ADDENDUM #4  
INVITATION FOR BID #22-01

**NECP Building Renovation Project (Re-bid)**

ADDENDUM NO. 04

Drawing A202 - Please provide an elevation of the partitions.

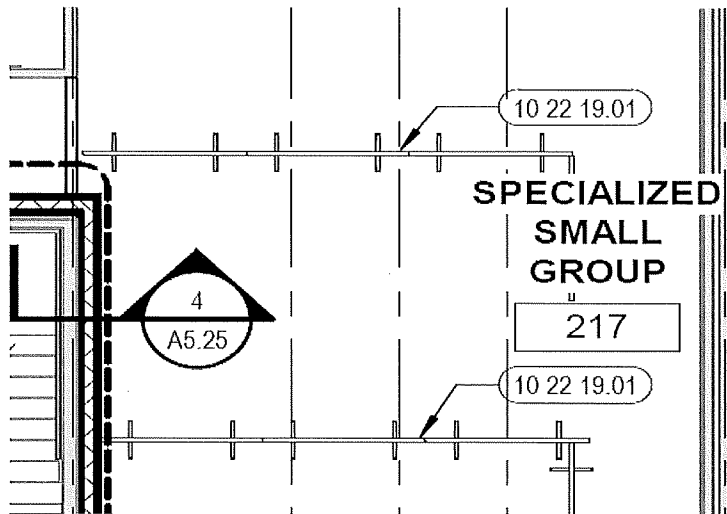
Q9. Please answer the following questions.

A9. See attached Addendum 4: Changes to Project Manual; Specification Section 102219, Part 2.1.A.2.a  
"partitions are to be 72" Tall."
